S/S LEOPOLDVILLE

MAZOUT SUCTION - & STEAM HEATING PIPES IN TUNNEL

ALTERATIONS IN WAY OF PALM OIL TANKS

PLAN N° 1503 - S/S

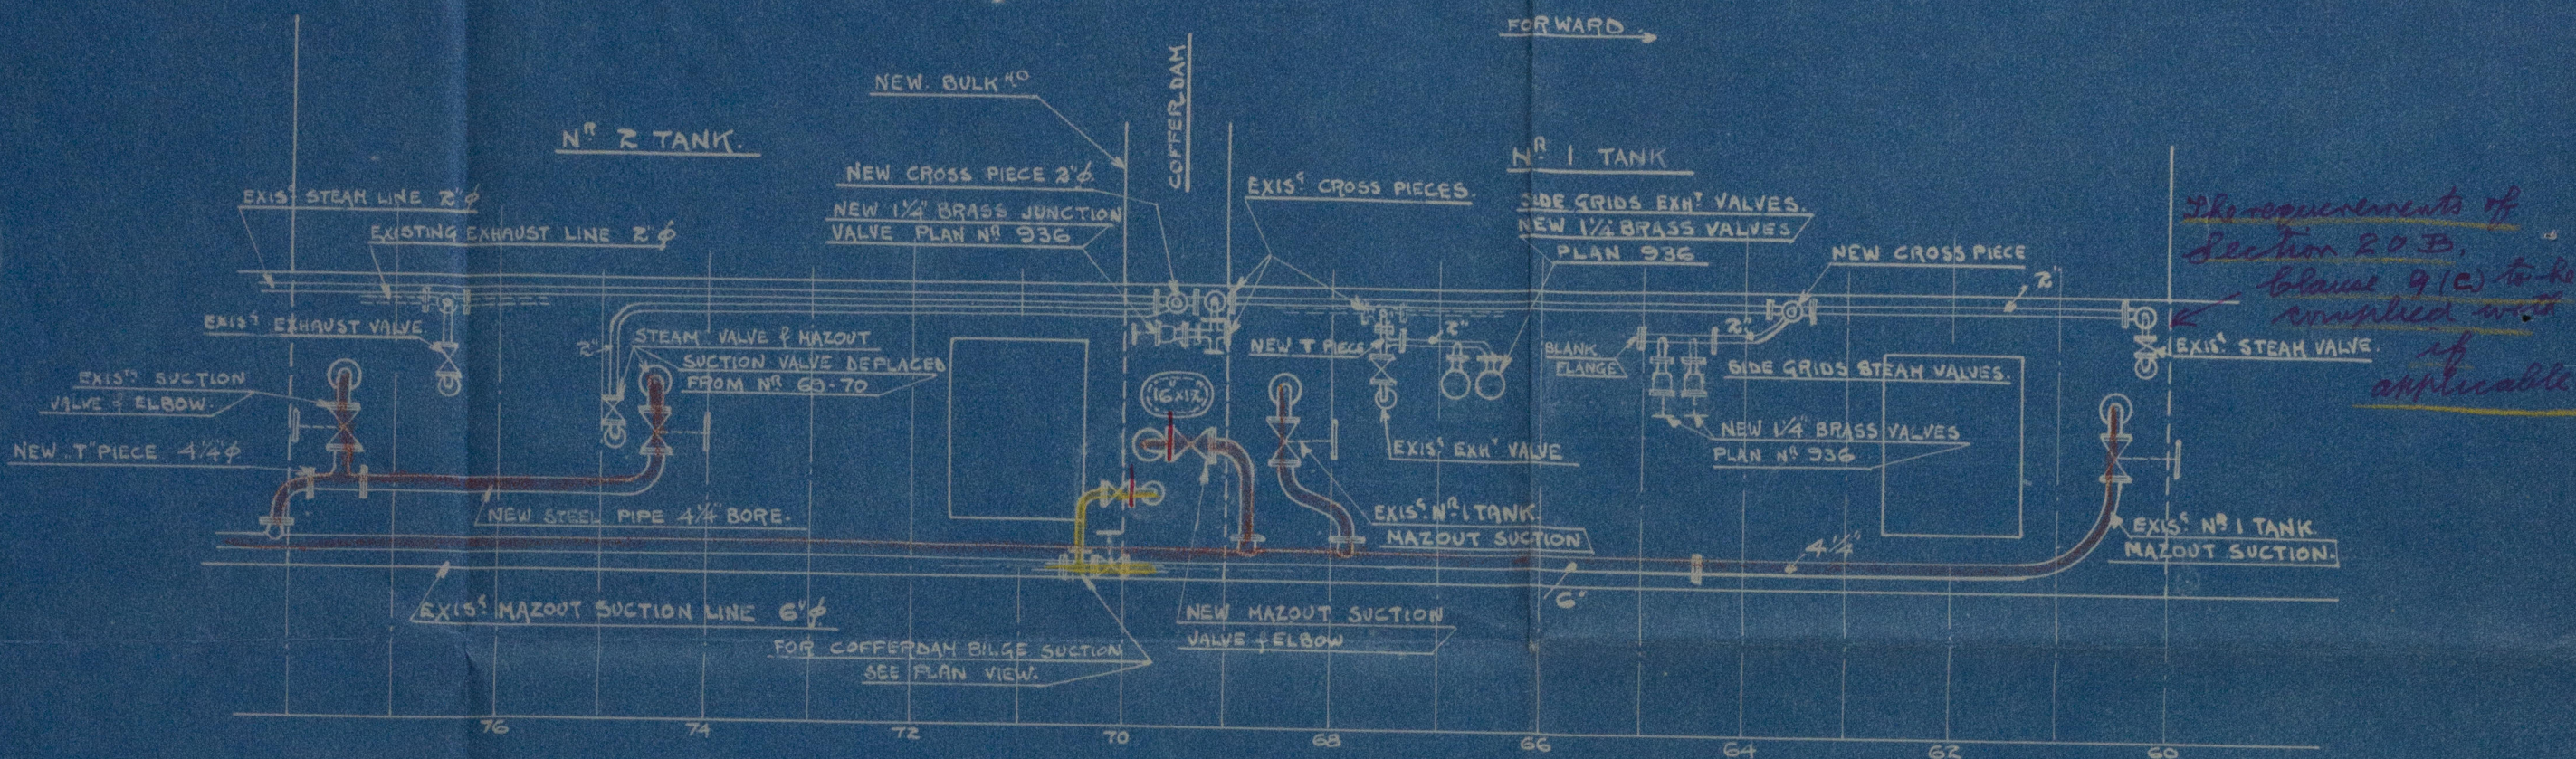
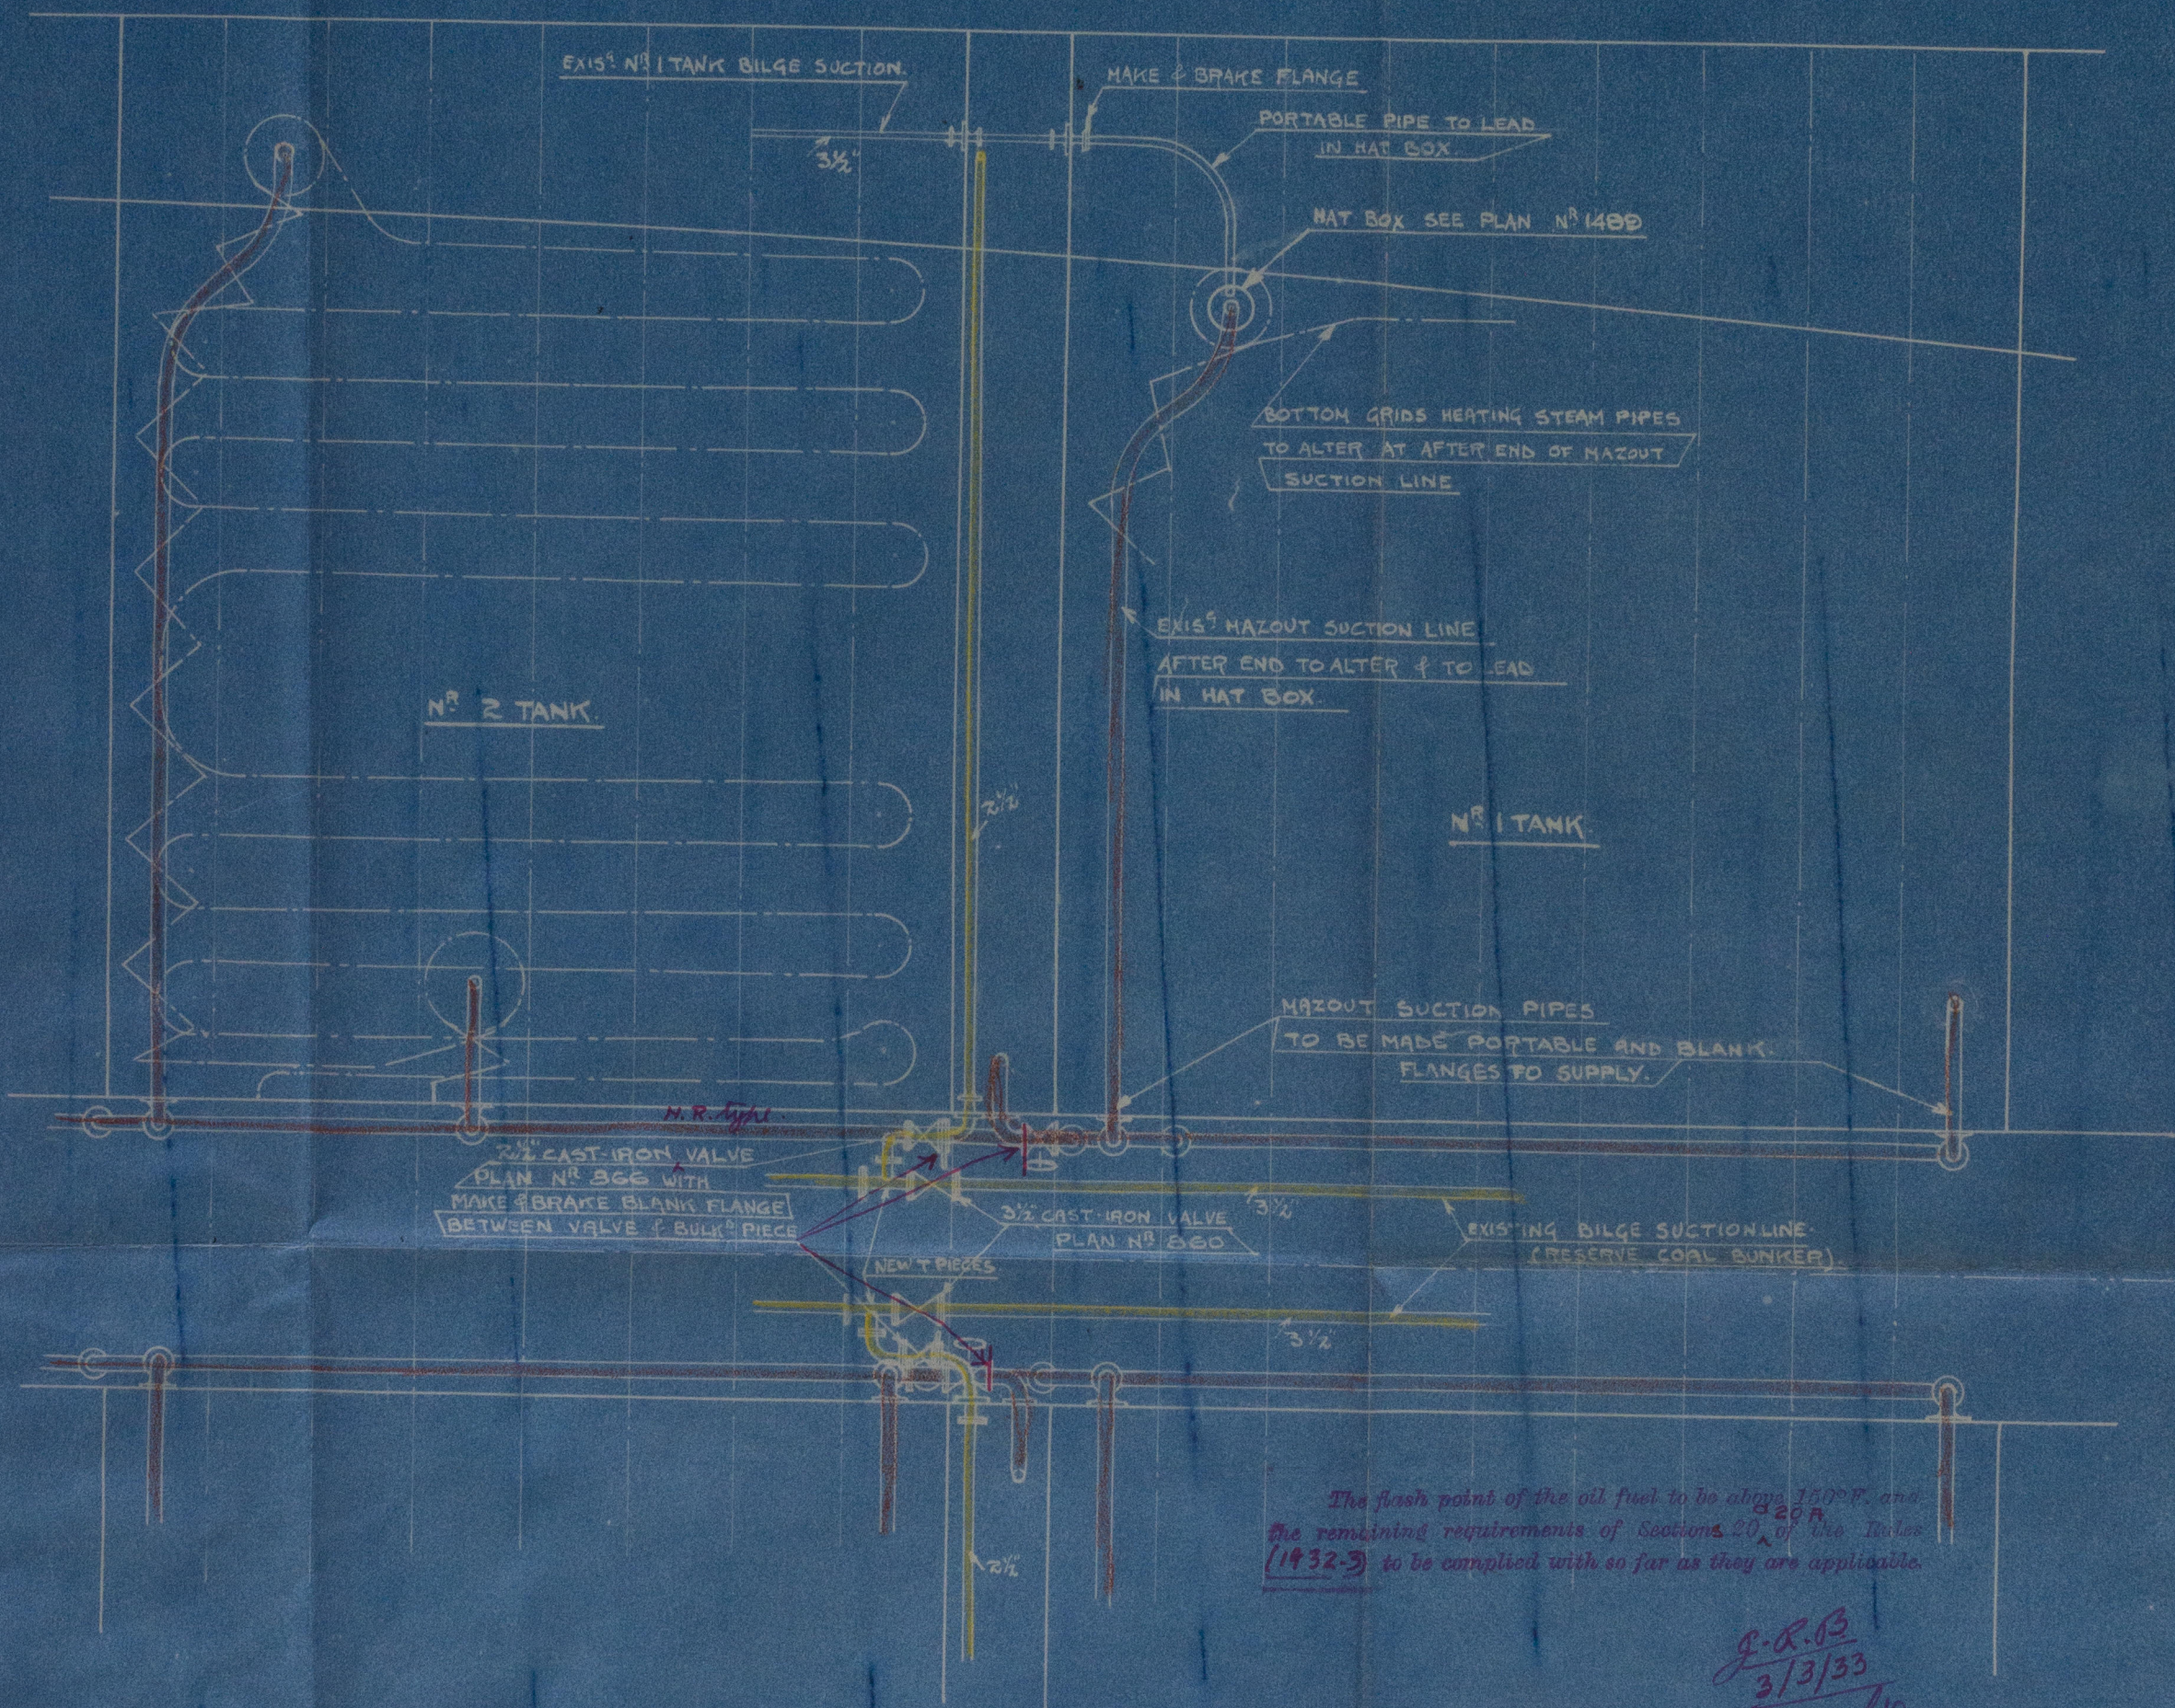
The requirements of Section 20 B, clause 9 (c) to be complied with if applicable.

The flash point of the oil fuel to be above 150°F and the remaining requirements of Section 20 of the Rules (1432-3) to be complied with so far as they are applicable.
